REQUEST FOR COUNCIL ACTION

Originating Department COMMUNITY DEVELOPMENT	By rms	Approved for Agenda by:	Date: Time:	Number:
Agenda Section DEVELOPMENT BUSINESS		Item Variances, conditional use and final site plan and building plans for a restaurant

Item 2		Case 8946ABC-94		
GENERAL INFORMATION				
Applicant:		FourCrown, Inc.		
Location:		9624 Lyndale Avenue		
Request:		Variances to: A) Reduce landscaped yard from 20 feet to 9 feet (Case 8946A-94); and B) Increase the number of allowable signs from 2 signs to 4 signs (Case 8946B-94) Conditional use permit and final site plan and building plans for a freestanding restaurant		
Existing Land Use and Zoning:		Vacant commercial building; zoned CB		
Surrounding Land Use and Zoning:		North, South and East - Retail Commercial; zoned CB and CB(PD) West - Manufacturing; zoned I-3		
Comprehensive Plan:		The Comprehensive Land Use Plan recommends Retail Commercial land use for the property.		
PROPOSAL				
The applicant is proposing to redevelop a 37,337 square foot lot for a 119 seat freestanding restaurant. The existing structure would be removed and a new one-story 3,793 square foot brick restaurant building would be constructed. Access from

PROJECT: WEHDY'S RESTAURANT	DATE: DEC 17 80 SCALE: 1"=10' DRAWN BY: J-J CHECKED BY:	REVISIONS: 1
TITLE: LANDSCAPE PLAN	SHEET: L-1

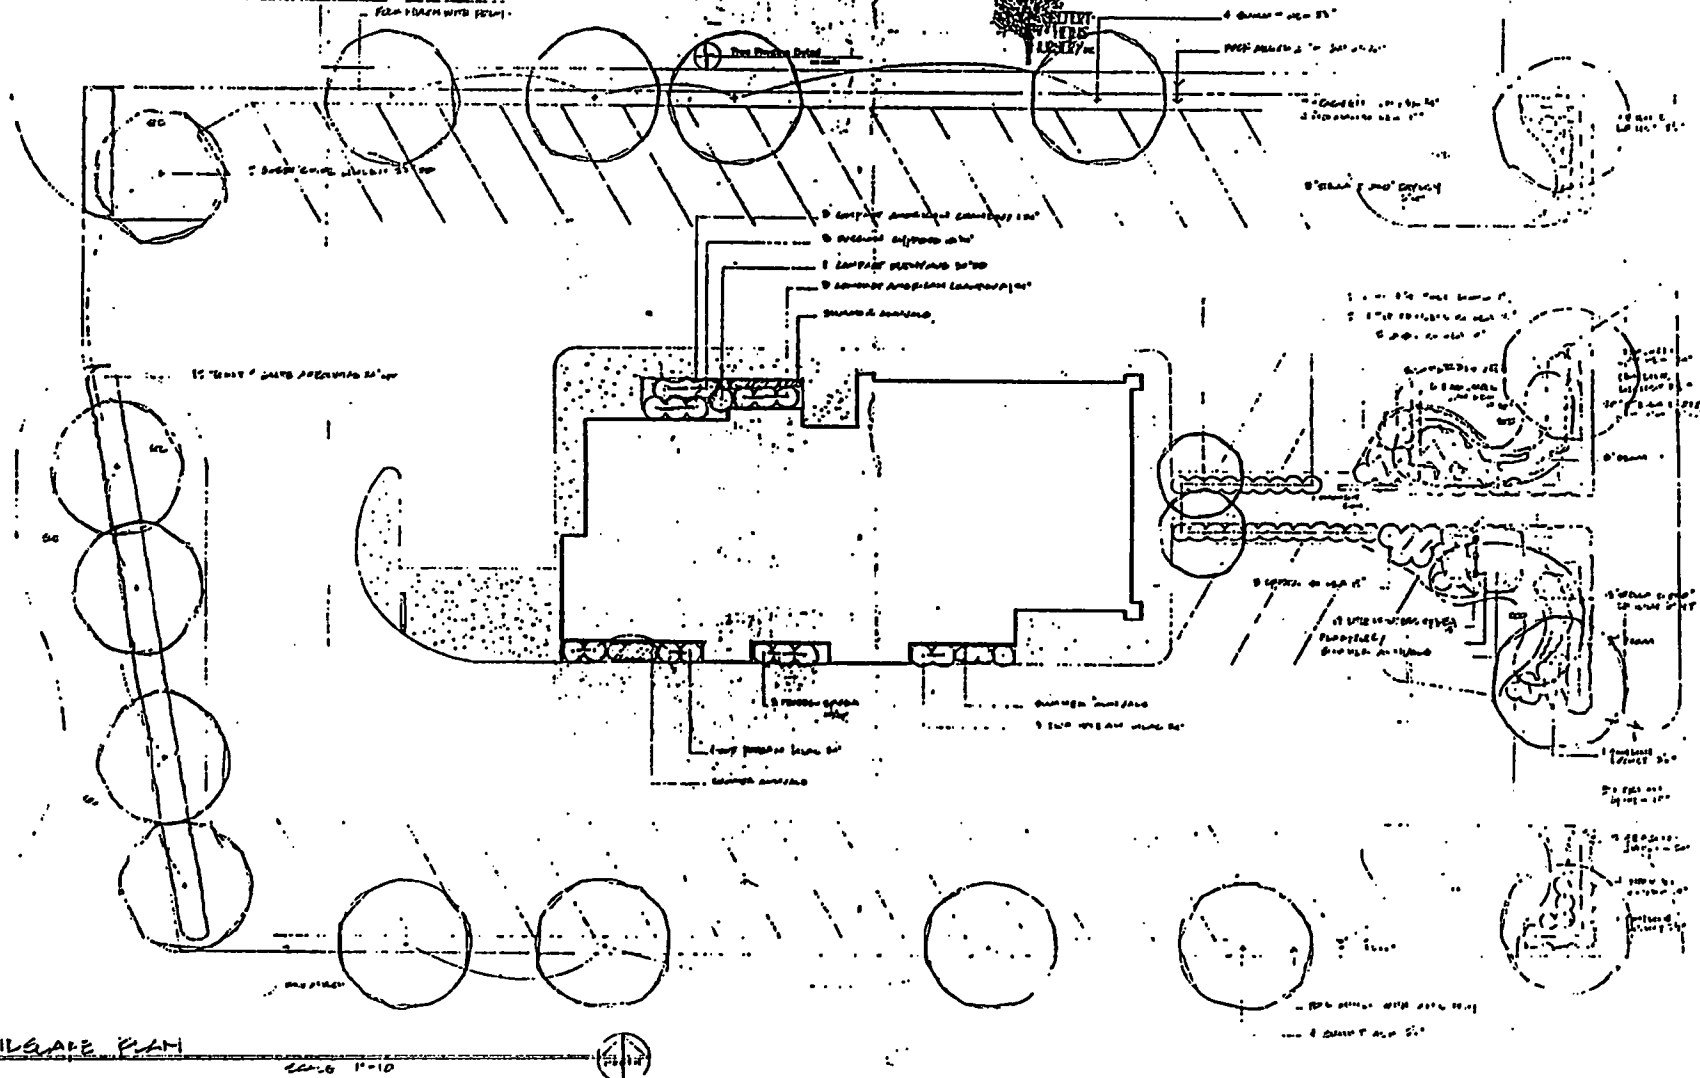
A conceptual landscape plan has been submitted noting perimeter shade tree plantings along the north, south and west property lines. Foundation plantings of low growing shrubs is proposed along the north and south sides of the building. Planting beds extend along a front sidewalk area to Lyndale Avenue. Streetscape plantings along the yard area adjacent to Lyndale Avenue is composed of deciduous shade or boulevard trees and shrubs. A finalized landscape plan, modified to incorporate elements of the Oxboro Redevelopment streetscape program, should be included as a condition of approval.

- 1) Landscape plan including Oxboro Redevelopment Area streetscape improvements be approved by the Planning Manager (Sec 19.52);
- 2) All rooftop equipment be fully screened (Sec. 19.52.01);
- 3) Poured-in-place concrete curbs be provided on the perimeter of parking lots and traffic islands (Sec 19.64);
- 4) Building be provided with an automatic fire sprinkler system as approved by the Fire Marshal (Mn Bldg Code 3802; Uniform Fire Code Ch 10.306);
- 5) Utility plan showing location of existing and proposed water main and fire hydrant locations be approved by the Fire Marshal and Utilities Engineer (Sec. 6.20, Uniform Fire Code Ch. 10.301-C);
- 6) Food service plans be approved by the Environmental Services Division (Sec. 14.360); and,
- 7) Fire lanes be posted as approved by the Fire Marshal (Sec. 8.73).

RECIRCULATION DRIVE – CONCEPT PLAN

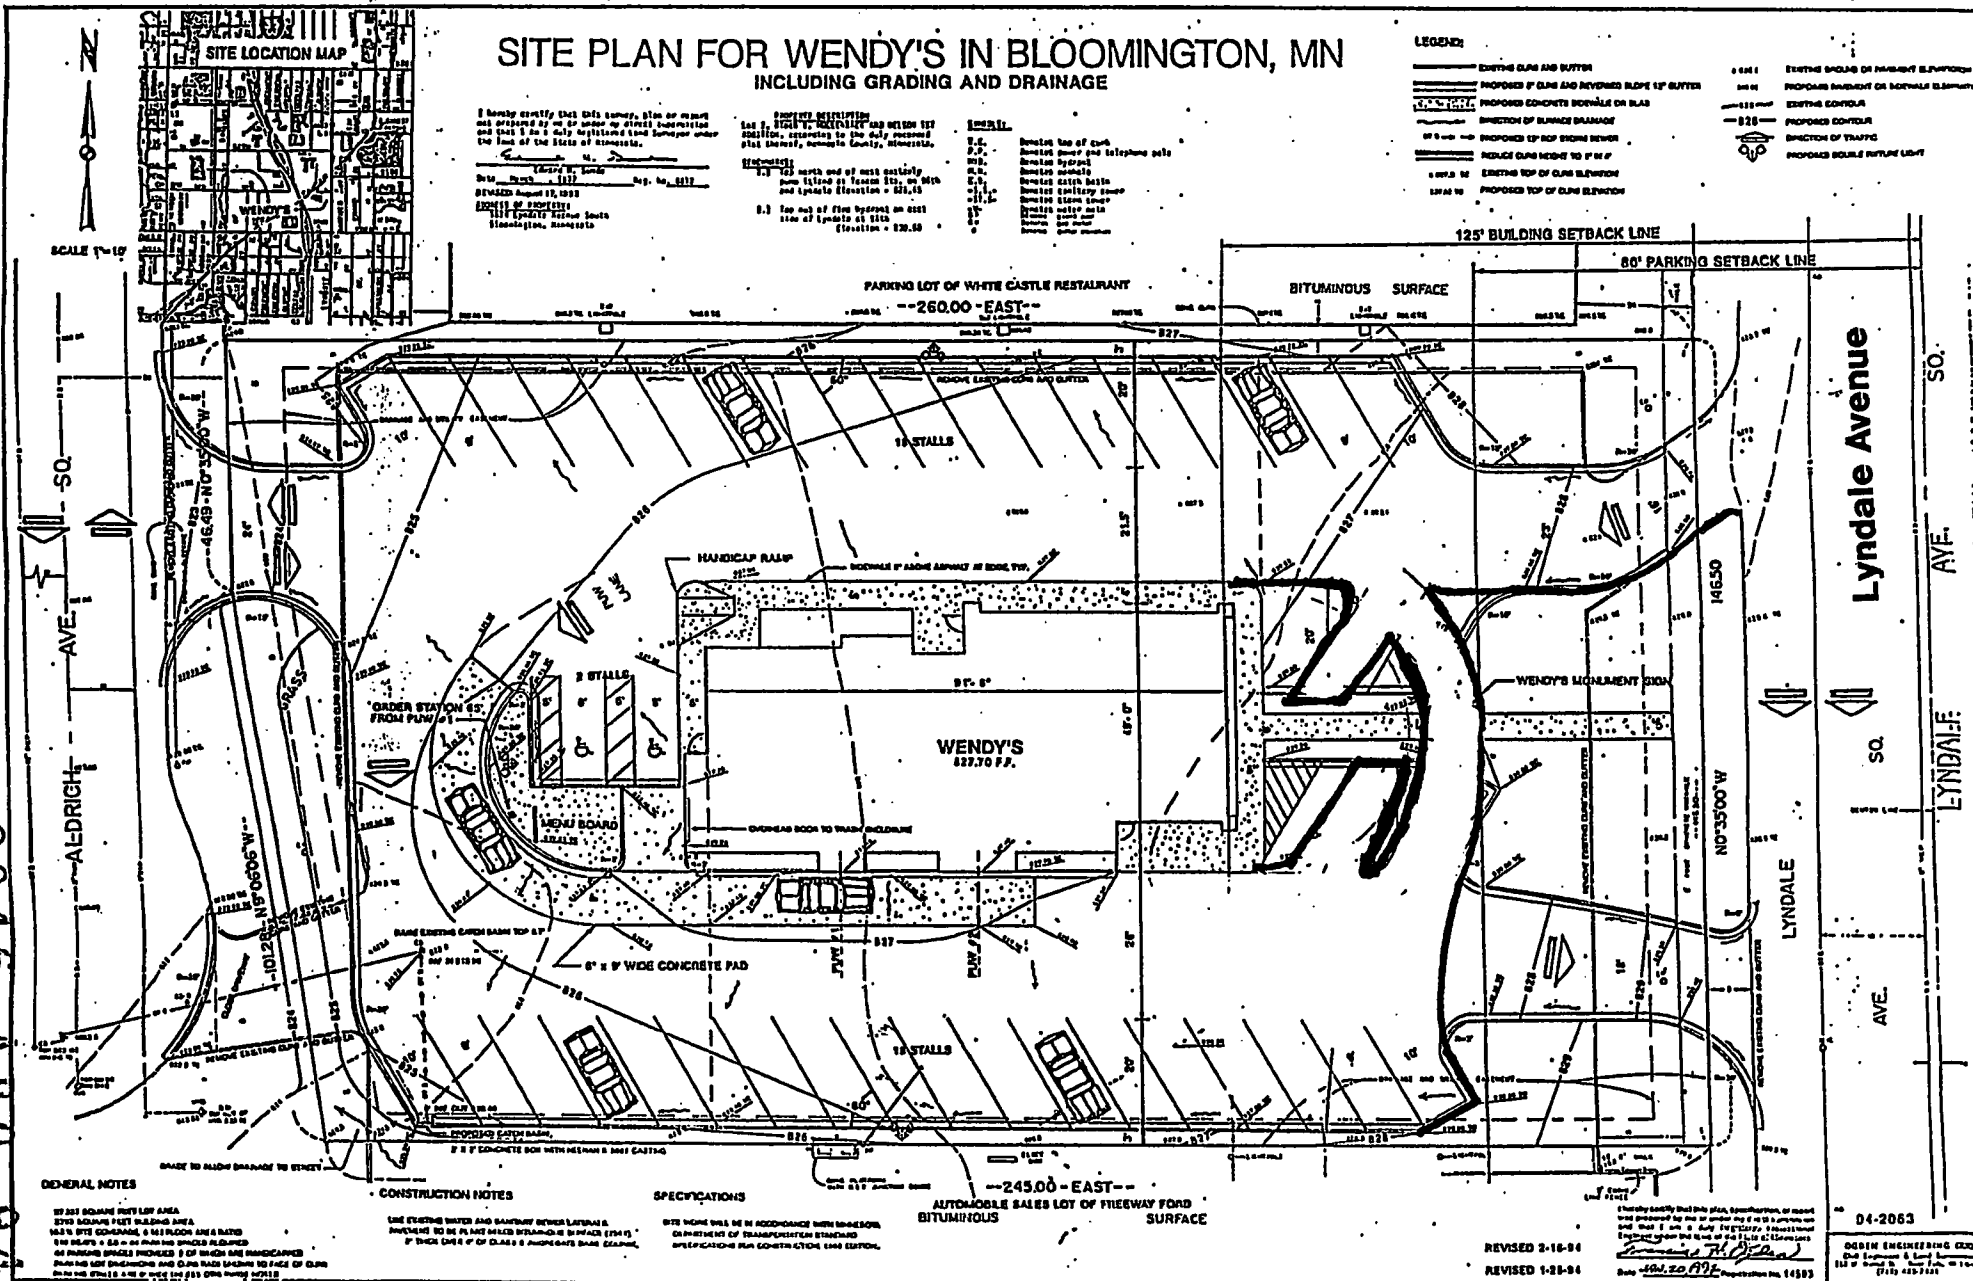
The City Traffic Engineer has recommend that the right-turn-out only exit to Lyndale Avenue be eliminated and a recirculation drive be placed that would channel exiting vehicles to leave the site via Aldrich Avenue to West 96th Street for both northbound and southbound Lyndale Avenue. The recirculation drive would be approximately 12 feet in width and the remaining area would provide a location for two handicapped accessible parking spaces. Exiting traffic for a right turn on southbound Lyndale would be from West 96th Street. This intersection will eventually be signalized.

The developers plan proposes an additional right turn egress to southbound Lyndale Avenue. The driveway doesn't exist and should not be permitted. Center channelization exists on Lyndale Avenue. The subject site is only a 146 foot wide parcel. To maintain the "downtown Bloomington" image and to continue proper design in safety and operations, it has been the City's plan to minimize the number of driveway openings onto Lyndale Avenue; to serve multiple developments via common access such as the shopping center concept. Allowing another driveway to Lyndale would have a "firing range" effect for motorists traveling that roadway. Hazards increase with driveway frequency. The roadway operational integrity diminishes the street quality and pedestrian systems are unnecessarily downgraded.

- ① The only access to Lyndale Ave shall be the existing
SIB to WIB Right turn ingress to site there shall be NO additional curbscuts
- ② It is necessary that there be an on-site re-circulation to provide
driveway within the Pkg lot @ the East side of the Bldg.

The Planning Manager informed the Council that the applicant, City Traffic Engineer and Public Works Department had come to an agreement on inclusion of a re-circulation drive through the center of the property, and the addition of a right-turn out driveway onto Lyndale Avenue. Condition of approval 5 was amended to include these changes:

5. Revised access, circulation and parking plans incorporating a re-circulation drive in addition to the right-turn out only access to Lyndale Avenue be approved administratively by the Planning Manager and the City Traffic Engineer. Any variances resulting from administrative requirements or revisions may be processed as administrative variances.
